# Access Compliance Report

## Public Rights-of-Way

### (Curb Ramps)

Intersection ID: N/A	Main Street: MEADOW_VISTA_RD	Cross Street: MONUMENT_HILL_RD	Location: NW
ADA ID: 7469DDAEFFFA	Ramp Type: PerpDiag	Initial Pass/Fail: Fail	Overall Compliance: No
			Severity Score: 33.75

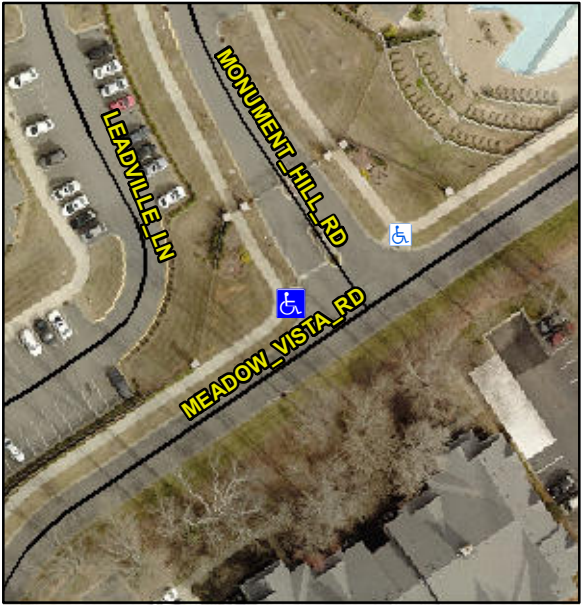
Codes/Mitigation Info/Possible Solution			Field Measurements/Component Compliance		
	Possible Solutions:		<b>Compliance</b>	<b>Description</b>	<b>Data</b>
	<b>Remove &amp; Replace Curb Ramp With Two New Directional Ramps or Equivalent.</b>		N/A	Ramp Length (in)	95.0
			No	Ramp Width (in)	41.5
			N/A	Flare Type LT	N/A
			N/A	Flare Slope LT (%)	N/A
			N/A	Flare Traversable LT?	N/A
			N/A	Landing Length (in)	N/A
			N/A	Landing Width (in)	N/A
			N/A	Landing Slope (%)	N/A
			N/A	Landing X Slope (%)	N/A
<p>Surveyor Notes:</p> <p><b>N/A</b></p> <p>PROW/ADA:</p> <p><b>Not Found, R304.5.1, R304.2.2, R304.5.3</b></p>			N/A	Flare Type RT	N/A
			N/A	Flare Slope RT (%)	N/A
			N/A	Flare Traversable RT?	N/A
			N/A	DWS Provided?	N/A
			N/A	DWS Contrast?	N/A
			N/A	DWS Length (in)	N/A
			N/A	DWS Full Width?	N/A
			N/A	DWS Offset (in)	N/A
			N/A	Shared Landing?	N/A
			N/A	Gutter Ponding?	N/A
			N/A	Gutter Lip Ht (in)	N/A
			N/A	Painted X Walk1?	No

X Walk 1 Direction	To S
			N/A	X Walk 1 Width (in)	N/A
				X Walk 1 Slope (%)	2.1
				X Walk 1 X Slope (%)	4.1
			N/A	Ramp inside XWalk1?	N/A
				Road Slope (%)	2.2
				Road X Slope (%)	4.2
			N/A	Any Obstructions?	N/A
				Obstruction Type	
					</
